Combs Unified School District, #44 Amendment #1		301 E. Combs Road San Tan Valley, AZ 85140
	IFB: 18-02-18 PROJECT: Roof Restoration and Weatherization at Jack Harmon Elementary	Page 1 of 4

March 19, 2018

CAMPUS ROOF RESTORATIONS AND WEATHERIZATIONS
JACK W. HARMON ELEMENTARY SCHOOL

Amendment #1
AS-BUILT CONDITIO

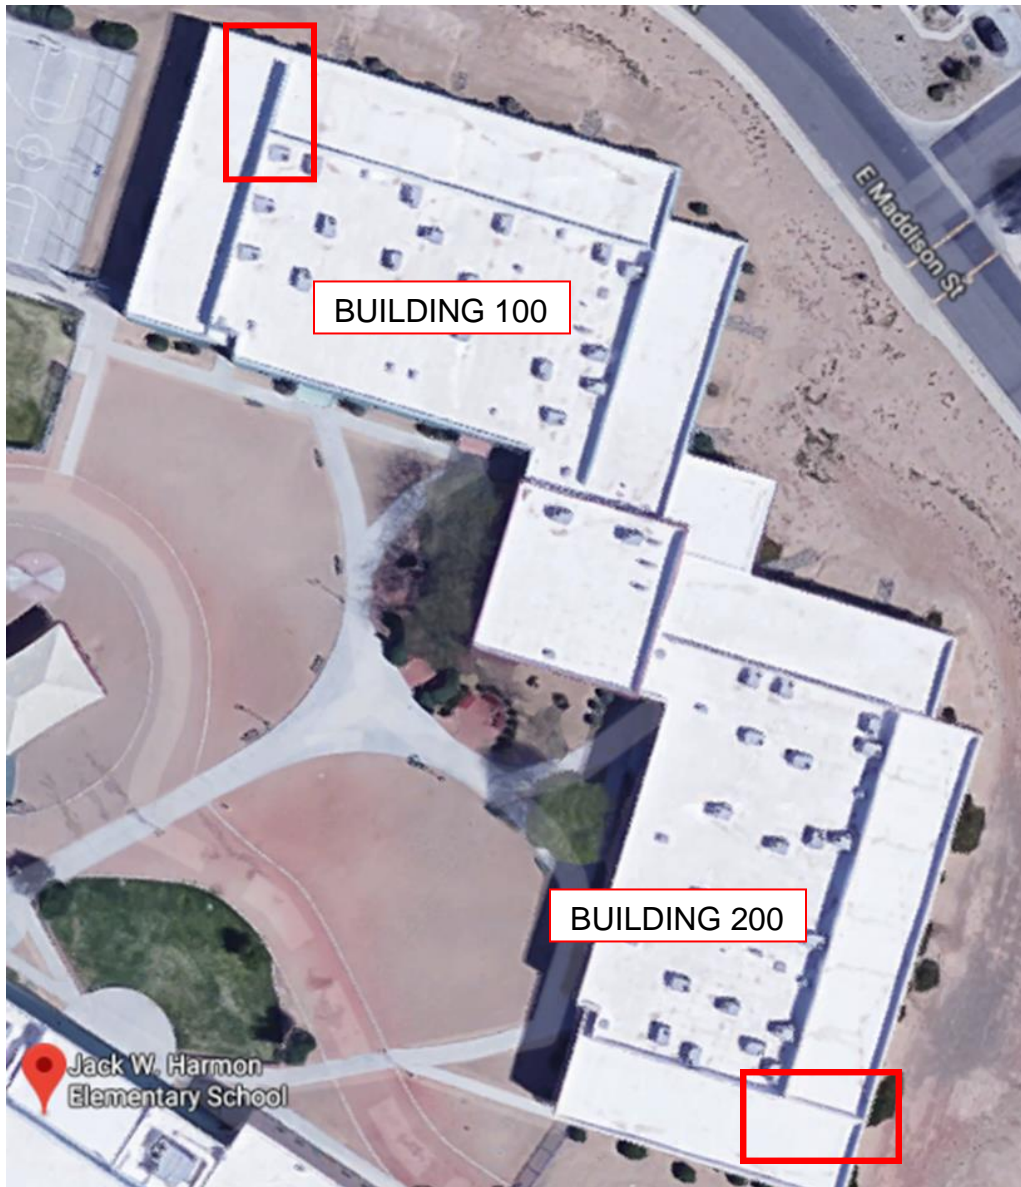
3. Note that as-built conditions vary from the roof plan of the original construction documents. Additional parapet walls have been constructed where shown within the rectangles on the diagram.
 - A. The added parapet at building 100 is the same height as the high interior parapet and finished with the same materials (painted stucco above and coated roofing below).
 - B. The added parapet at building 200 is the same height as the low exterior parapet and finished with the same materials as the back of the exterior parapet (coated roofing).

Note that as-built conditions vary from the roof plan of the original construction documents. Additional parapet walls have been constructed where shown within the rectangles on the diagram.

- The added parapet at building 100 is the same height as the high interior parapet and finished with the same materials (painted stucco above and coated roofing below).
- The added parapet at building 200 is the same height as the low exterior parapet and finished with the same materials as the back of the exterior parapet (coated roofing).
